OXFORDSHIRE
STRATEGIC RAIL FREIGHT INTERCHANGE

Chapter 3: Transport
Appendix 3.1: Transport Assessment Part 10 of 11

M40 J9 HIGHWAY DESIGN REVIEW

Project	**Oxfordshire Strategic Rail Freight Interchange (OxSRFI)**		
Document Number	OxSRFI-BWB-GEN-XX-RP-CH-0015	**BWB Ref**	NTH2479
Author	[redacted]	**Status**	S3
Checked		**Revision**	P01
Approved		**Date**	24.03.2026

Drawings OxSRFI-BWB-HGN-27-DR-CH-0105 and OxSRFI-BWB-HGN-28-DR-CH-0105 Geometrical Layout Sheets

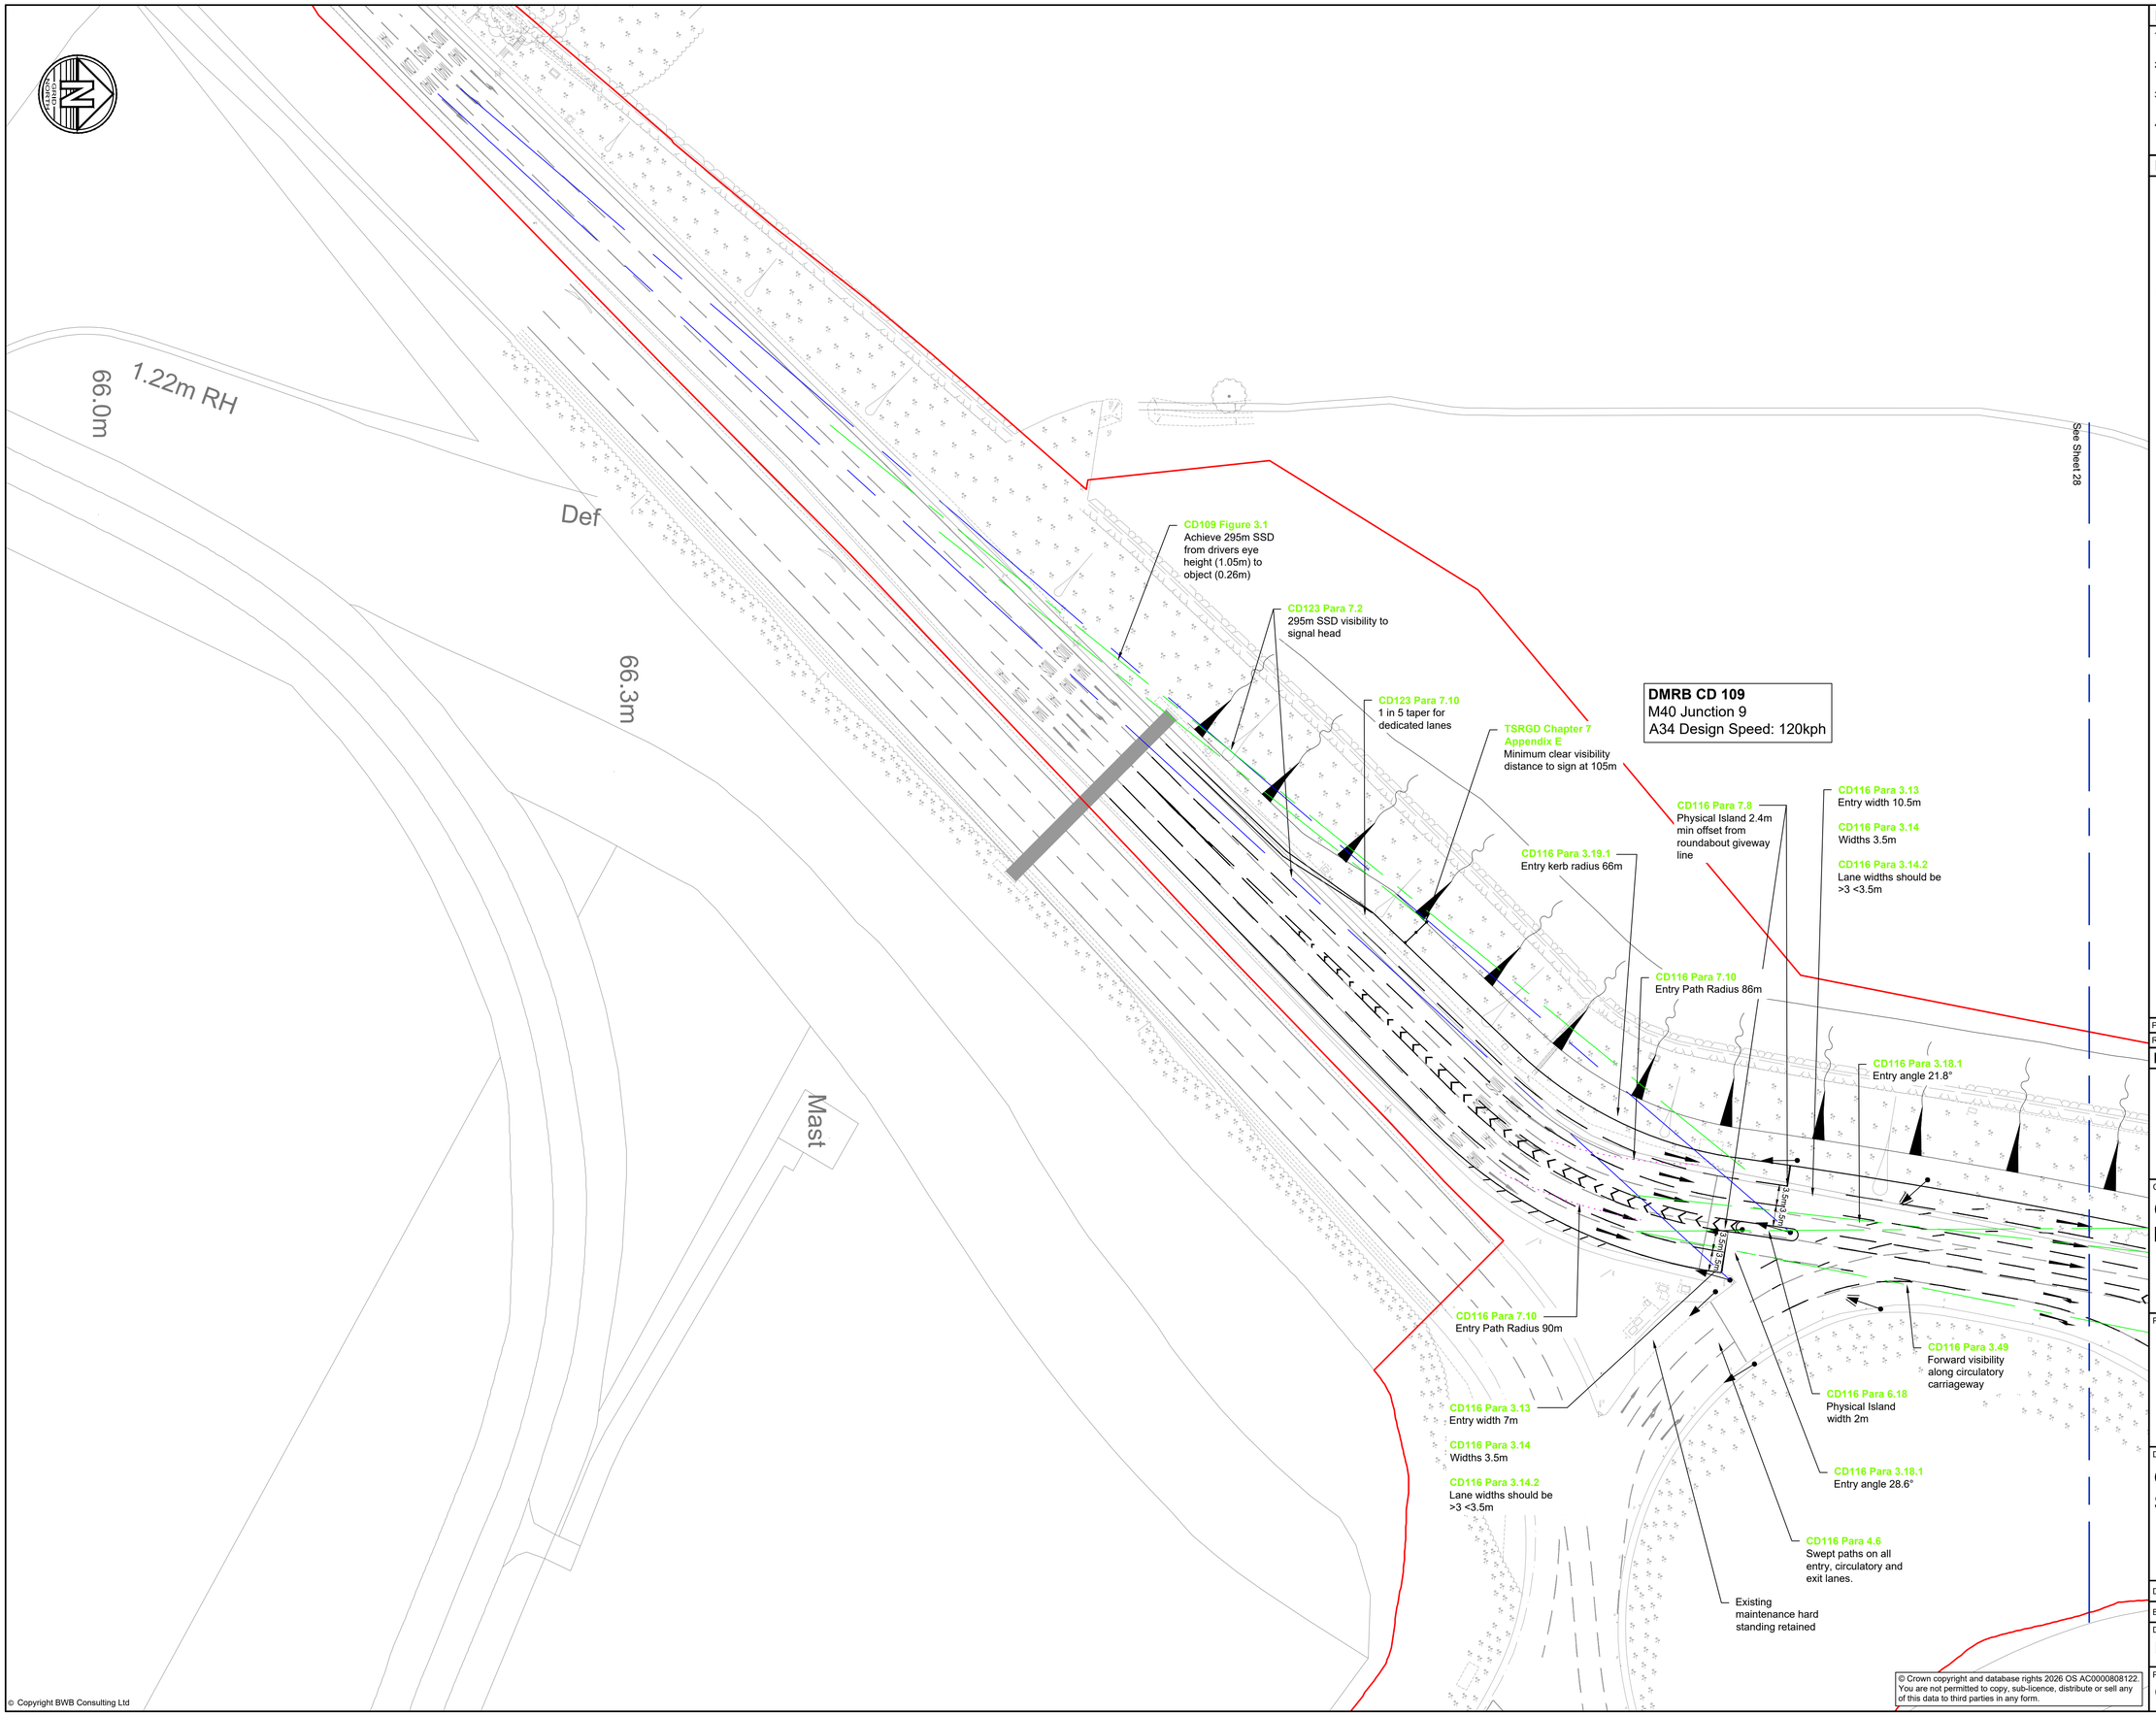
3.2	The scheme is shown at scale 1:2500 on an inset to a larger drawing with no dimensions provided. A larger scale plan, annotated with key dimensions and their compliance with DMRB, and a CAD drawing of the scheme, should be provided, to facilitate AECOM's review.	The following larger scale plans showing the works, including assessment of compliance with DMRB, are found at **Appendix B** to this technical note: OxSRFI-BWB-HGN-27-DR-CH-0105 OxSRFI-BWB-HGN-28-DR-CH-0105 In addition the cross-sections are shown on **DCO Document 2.7M**

AECOM report ref	AECOM comment	BWB response
3.4	Earthworks are shown on the drawing, but the extent and adequacy of these cannot be determined without a 3-dimensional layout. The extent of vegetation clearance is not shown. The positions of the relocated VRS, traffic signal poles and street lighting columns are also not shown. These should be provided, at least indicatively, so as to confirm the adequacy of the verge proposed.	See above response in terms of earthworks and verge width for assets. Traffic signal locations are indicated on drawing OxSRFI-BWB-HGN-27-DR-CH-0105 found at **Appendix B**.

3.6	Since the signage strategy is to be updated, the location of any additional signs proposed on the A34 approach (or elsewhere) should be shown, at least indicatively, and it should be confirmed that the proposed earthworks are sufficient to accommodate them. The impact of any such signs on visibility spays should be considered, as should the need for additional vegetation clearance to achieve such splays.	The signage strategy (as above) proposes an additional dedicated lane sign, the location of which is shown on drawing OxSRFI-BWB-GEN-XX-SK-CH-SK058 (**TA Appendix 40**) with the visibility splay to this sign is also indicated on OxSRFI-BWB-HGN-27-DR-CH-0105 (**Appendix B**).

3.13	The taper by which the third lane is lost on the M40 slip road starts downstream of the bend approximately 40-50m into the slip road. This is to be welcomed. The adequacy of the taper length proposed should be confirmed by reference to CD 116 Figures 3.14b and 3.14j and para 3.19 (which in turn refers to TSM ch5 Table 7-4).	The lane reduction taper is shown in detail on drawing OxSRFI-BWB-HGN-28-DR-CH-0105 found at **Appendix B**. This is compliant with CD 127 Table 2.28.
